## **Hillphoenix Comments on the DOE NOPR for Commercial Refrigeration Equipment Products (CRE) Energy Conservation Standard and Technical Support Document**

CHART 1

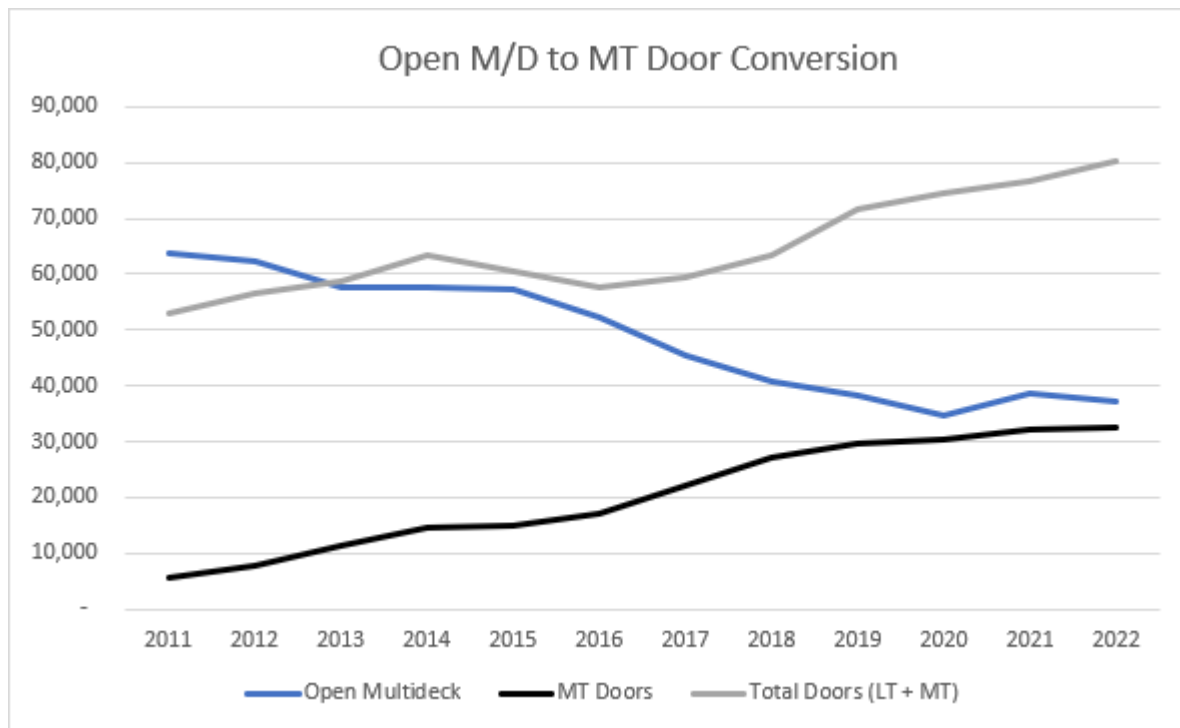
Many of the closed equipment classes, including HCT, VCT, and VCS, are concerning as the industry continues to transition to closed cases for additional energy savings. Requiring further reductions in energy use for these classes will require design changes to achieve minimal efficiency gains, while driving a cost increase for closed equipment classes. This cost increase of closed vs. open CRE will slow the transition from open cases to more energy efficient closed/door models. These classes already have very stringent energy limits with little room left for further energy reduction. Any CRE with lids or doors saves approximately 60% energy over their open display counterparts. See the growth of CRE VCT.RC.M Equipment class (MT Door Cases) and the decline of VOP.RC.M (MT open cases) in Chart 1 below. Many retailers have converted their VOP/HZO equipment class open cases to VCT/HCT classes by retrofitting doors in existing installations to capture the afore-mentioned energy savings. Requirements for further energy reduction will lead to many closed products being discontinued from the market, which is counter to the goal of reducing energy consumption.
